**SUBDIVISION &
ZONING AMENDMENT STAFF REPORT****Date: August 6, 2020****APPLICANT NAME**

Circle K at Skyland Park, Addition to

LOCATION4350 and 4362 Government Boulevard
(Northwest corner of Government Boulevard and Polaris Drive).**CITY COUNCIL
DISTRICT**

Subdivision Approval to create two (2) legal lots of record from one (1) existing legal lot of record and one (1) existing metes-and-bounds parcel, and Rezoning from R-1, Single-Family Residential District, to B-2, Neighborhood Business District for proposed Lot B.

DETAIL SITE PLAN

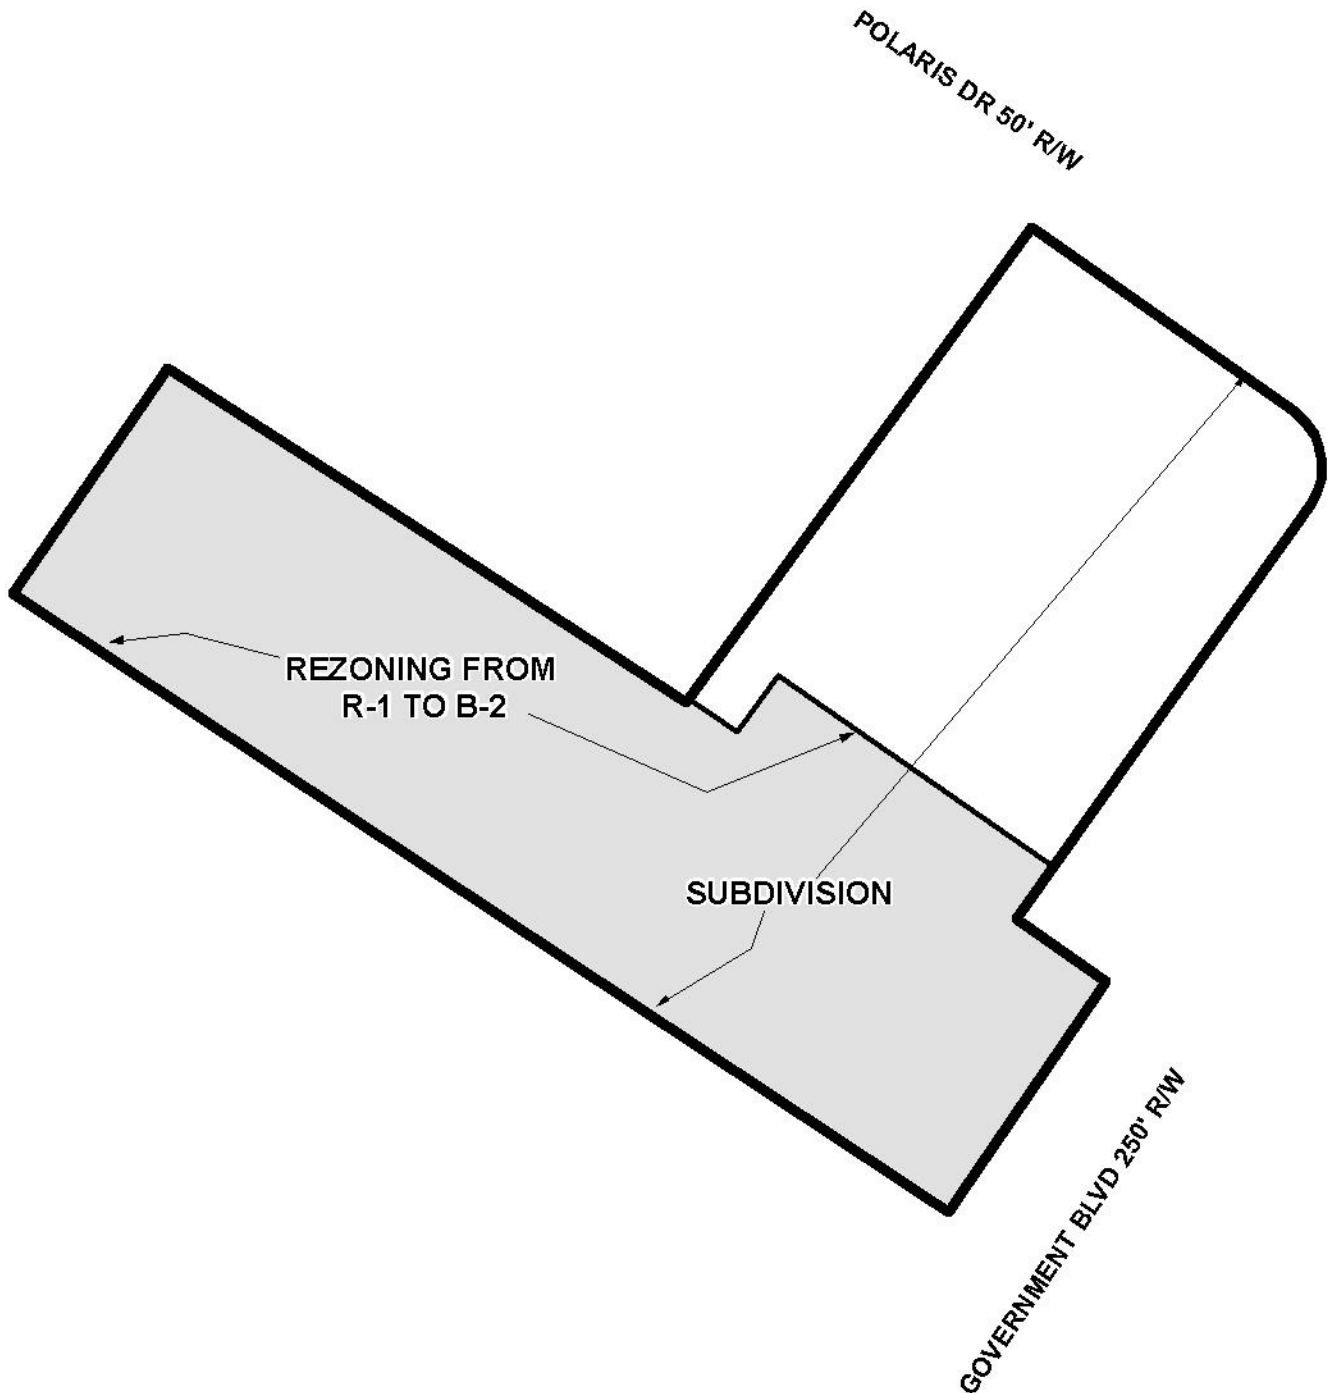
For proposed Lot A (the corner lot used residentially), the preliminary plat indicates a 35' front yard setback along Polaris Drive and a 50' side street yard setback along Government Boulevard. These setbacks were depicted on the 1955 recorded plat for Skyland Park Subdivision, Fourth Unit, and should remain on the Final Plat, if approved. For proposed Lot B (the commercial lot), the preliminary plat indicates a 25' front setback along Government Boulevard for the portion of that proposed lot currently used commercially. For the proposed expanded portion taken from the corner lot, no setback is indicated along the Government Boulevard frontage. Therefore, the plat should be revised to indicate a 25' setback from Government Boulevard along the entire lot.

- 1) *revision of the plat to provide a 25' minimum side street yard building setback line along Highway 90 Drive for Lot A;*
- 2) *revision of the plat to provide a 25' minimum building setback line along Highway 90 Drive for the expanded portion of Lot B;*

- 3) *revision of the plat to provide a 10' minimum building setback line along the East property line from the West terminus of Highway 90 Drive for Lot B; and*
- 4) *retention of the 25' minimum building setback line along Government Boulevard for Lot B.*

Regarding the setback concerns, at this point, staff proposes that a 25-foot minimum building setback line be maintained parallel to Polaris Drive, Government Boulevard and Highway 90 Drive. Where Highway 90 Drive terminates into Lot B, along this portion, a 10-foot setback is proposed, which will allow for the existing building.

- 1) *revision of the plat to provide a 25' minimum side street yard building setback line along Highway 90 Drive for Lot A;*
- 2) *revision of the plat to provide a 25' minimum building setback line along Highway 90 Drive for the expanded portion of Lot B;*

- 3) *revision of the plat to provide a 10' minimum building setback line along the East property line from the West terminus of Highway 90 Drive for Lot B;*

- 4) *retention of the 25' minimum building setback line along Government Boulevard for Lot B;*
- 5) *provision of a 25' (or greater) minimum building setback line along Polaris Drive;*
